Pentium® Processor Specification Update

Release Date: September, 1997

Order Number 242480-030

Figure14-1. Maximum Undershoot Level, Undershoot Threshold Level, and Undershoot Threshold Duration

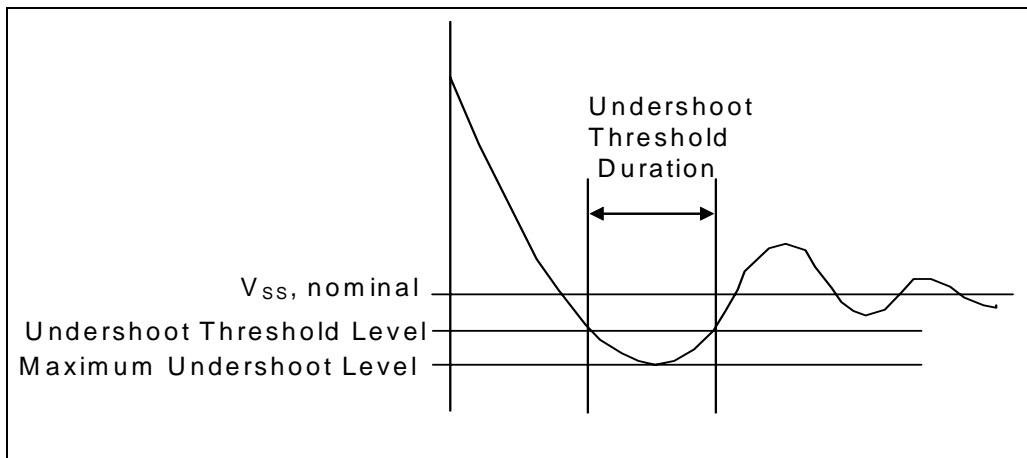
MAXIMUM RINGBACK SPECIFICATION: The maximum ringback of CLK associated with its low state (undershoot) must not exceed 0.8V as shown in Figure 14-1.

MAXIMUM UNDERSHOOT AND MAXIMUM RINGBACK SPECIFICATIONS: The display should show continuous sampling (e.g., infinite persistence) of the waveform at 500 mV/div and 5 ns/div (for CLK) for a recommended duration of approximately five seconds. Adjust the vertical position to measure the maximum undershoot and associated ringback. There is no allowance for crossing the maximum undershoot or maximum ringback specifications.

UNDERSHOOT THRESHOLD DURATION SPECIFICATION: A snapshot of the clock signal should be taken at 500 mV/div and 500 pS/div (for CLK). Adjust the vertical position and horizontal offset position to view the threshold duration. The undershoot threshold duration is defined as the sum of all time during which the clock signal is below -0.5V within a single clock period. The undershoot threshold duration must not exceed 20% of the period.

This undershoot specifications are illustrated graphically in Figure 14-1 and Figure 14-2.
